Liverpool Civic Place

Supplementary Design Report

fjmt studio architecture interiors urban landscape community
May 4 – Master Plan – Rev 0

fjmt prepared the Architectural Master Plan Design Statement which formed part of the 2019 formal lodgement. This supplementary report is intended to be read in conjunction with that original design statement, and provides a response to items raised by the approval consent authority. Numerous items are covered as follows:

2019 Masterplan Envelopes (with existing Terminus Street configuration): Terminus Street is not currently a highly used pedestrian sidewalk due to its lack of a direct pedestrian crossing and vehicular lay-bys, as well as its industrial nature.

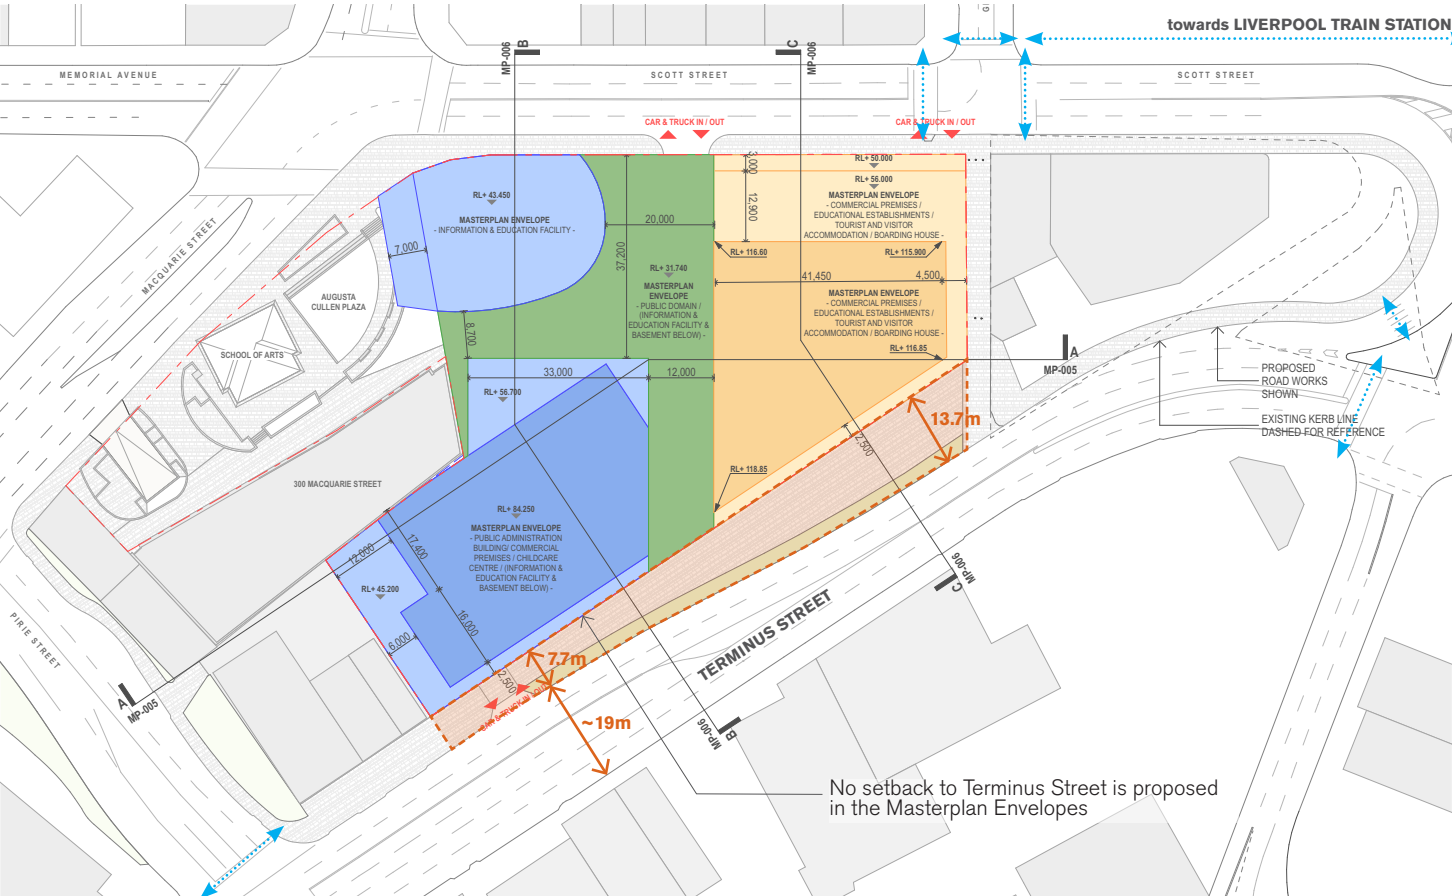
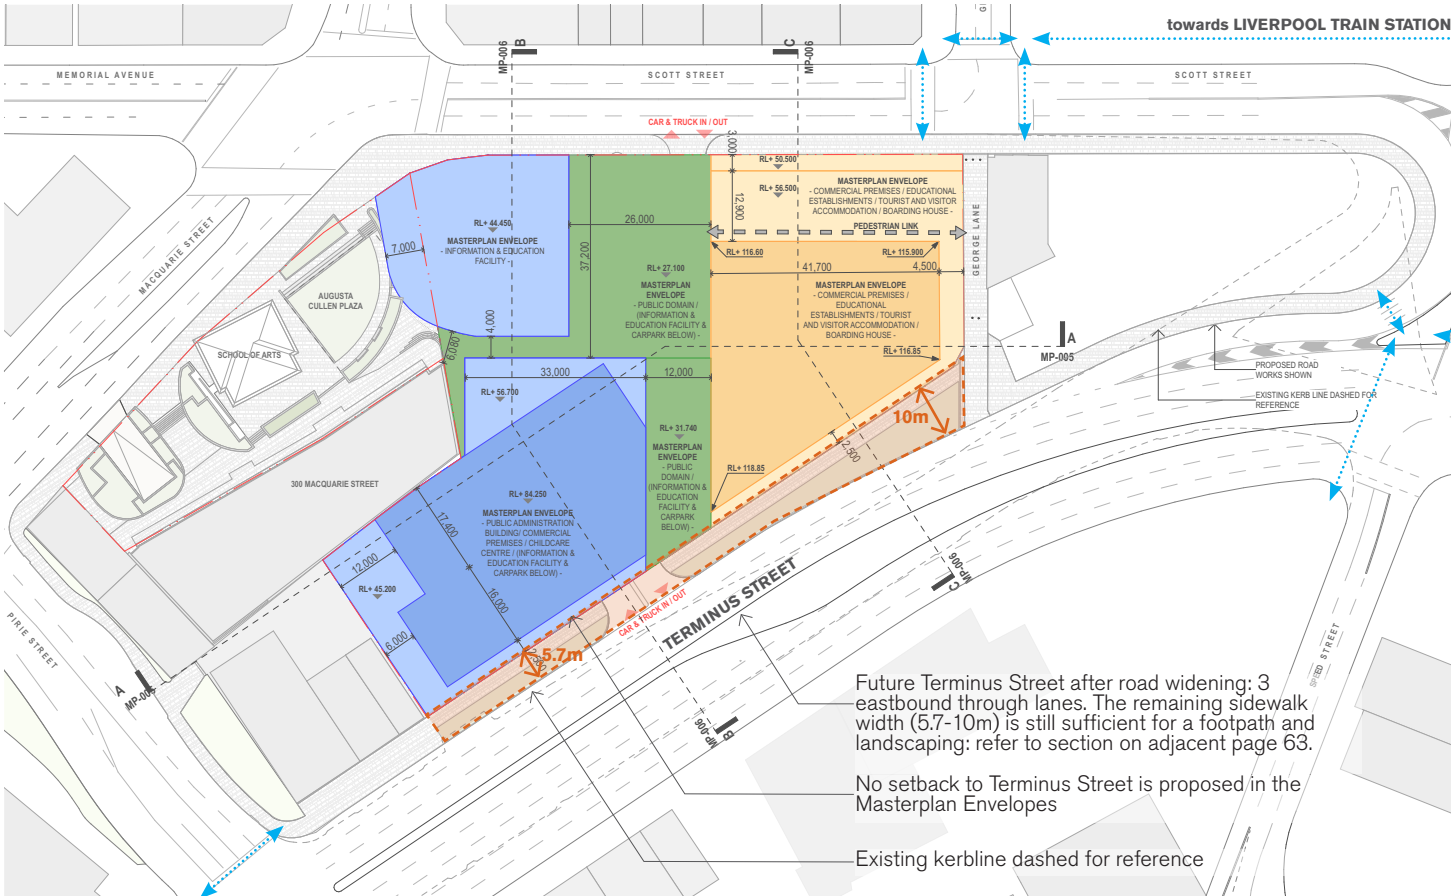
This chapter responds to RFI Arch 1I (Terminus Street) and Arch1M (Road reservation acquisition area)

The plans below compare the existing Terminus Street configuration with the future 6-lane configuration after road widening, with key dimensions highlighted in orange. No land use or building envelope is proposed in areas subject to road reservation acquisition.

Comparing the resultant sidewalks (5.7-10m wide) to the Liverpool City Centre Public Domain Master Plan and Transport NSW's Shared Paths research, suggests ample width is provided for a shared pathway and a landscape verge in this setting. This is supported by local precedents cited in chapter 10.2.
